Justification for Various Aspects of
the Re-evaluation Criteria in response to
NRC's December 22, 1981 request for
additional information concerning
IE Bulletin No. 80-11 "Masonry Wall Design"

Consolidated Edison Company of New York, Inc.
Indian Point Unit No. 2
Docket No. 50-247
August, 1982

**INDIAN POINT GENERATING STATION, UNIT 2
REEVALUATION OF MASONRY WALLS**

**RESPONSE
TO
NUCLEAR REGULATORY COMMISSION REVIEW**

FIGURE 3-5 DISTRIBUTIONS OF OBE AND SSE STRAIN DATA

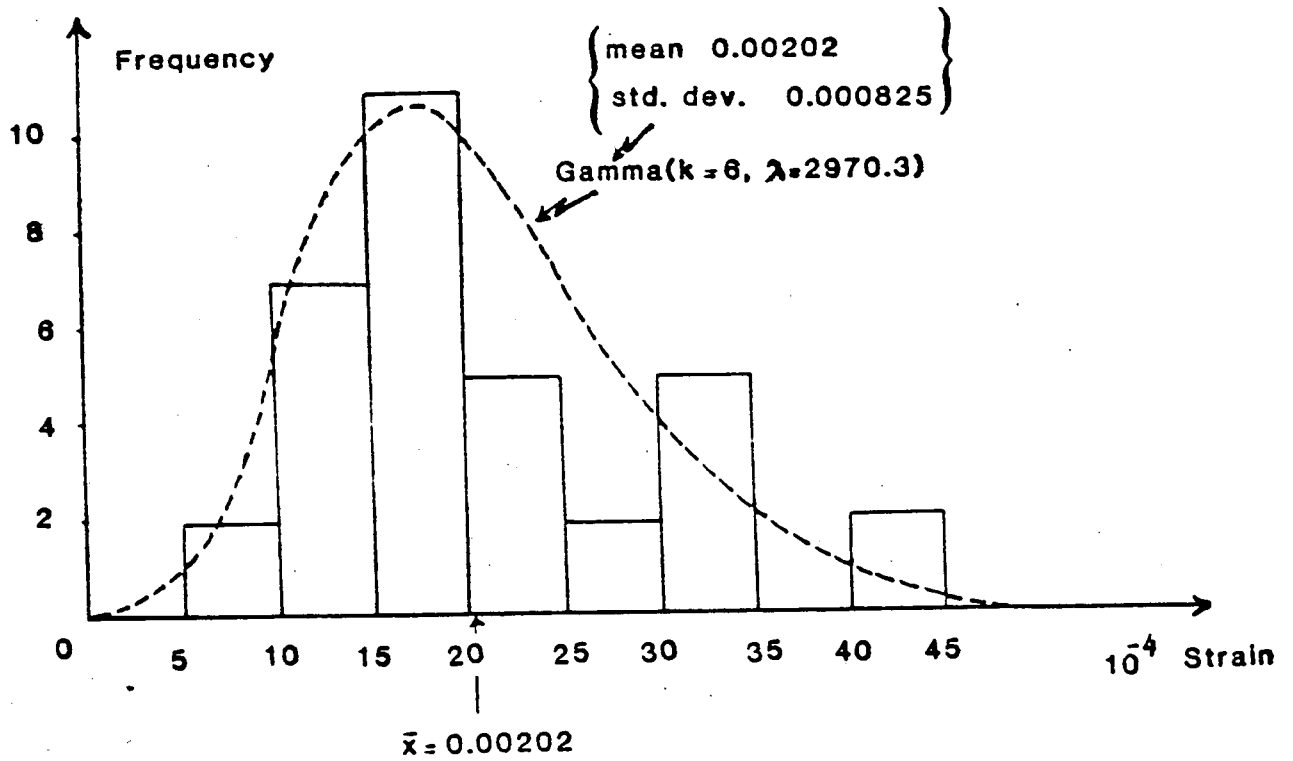
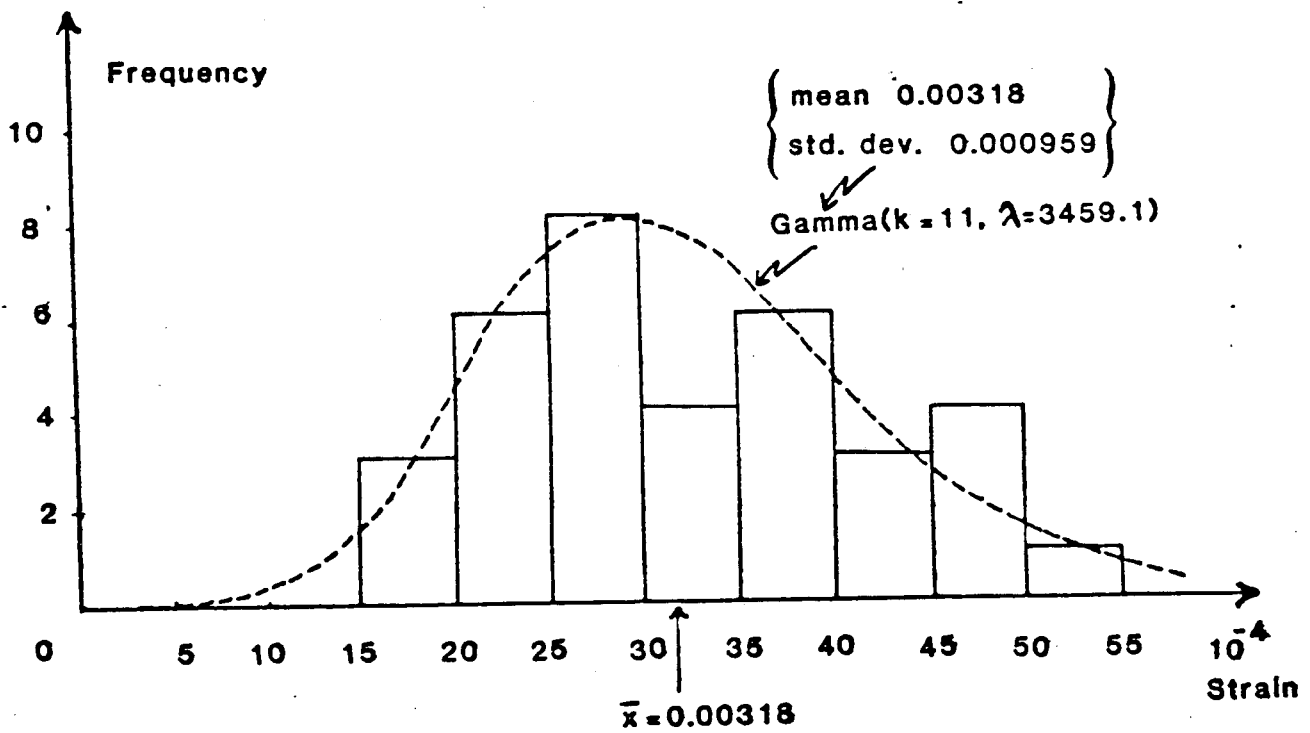
"The licensee should justify the proposed 67% increase in gross shear strains for factored loads".

The effect of the assumption of normal distribution versus the assumption of gamma distribution was studied. Plots of the histograms of test data for both the OBE and SSE conditions are shown in Figure 3-5. Two observations are as follows.

These curves are also plotted in Figure 3-5.

From the above discussion of results it is concluded that the criteria specified increase factor of 1.67 for shear strain for factored loads is reasonable for the reevaluation of the masonry walls at Indian Point, Unit 2.

FIGURE 6-1 CONFIDENCE INTERVALS FOR POPULATION STATISTICS

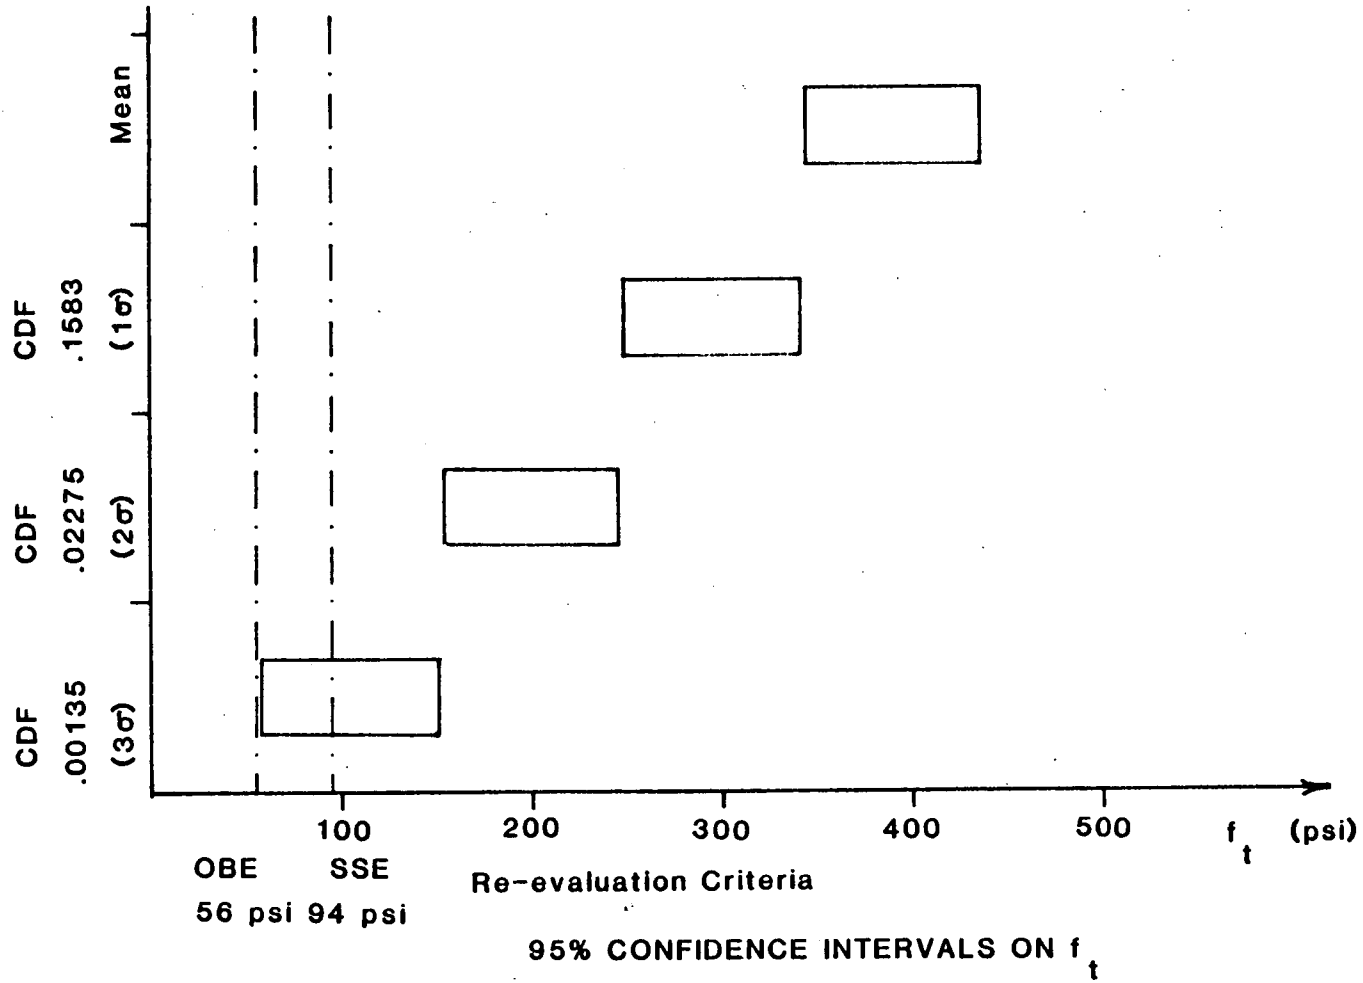
"For factored loads, the licensee suggests a 67% increase in allowable stresses for tension parallel to and perpendicular to the bed joint. However, the SEB criteria allow only 50% and 30% increases, respectively".

The key results for the confidence intervals are plotted in Figure 6-1, together with the OBE and SSE allowable stresses from the reevaluation criteria. The confidence intervals for the data are relatively narrow ($\pm 11.8\%$ for the mean). It is seen that the OBE allowable stress lies below the "mean minus three standard deviations" confidence interval whereas the SSE allowable stress lies within the "mean minus three standard deviations" confidence interval.

In view of the above discussion of results, it is concluded that the criteria specified increase factor of 1.67 for tensile stresses parallel to the bed joint for brick walls for factored loads is reasonable for the reevaluation of the Indian Point Generating Plant, Unit 2.
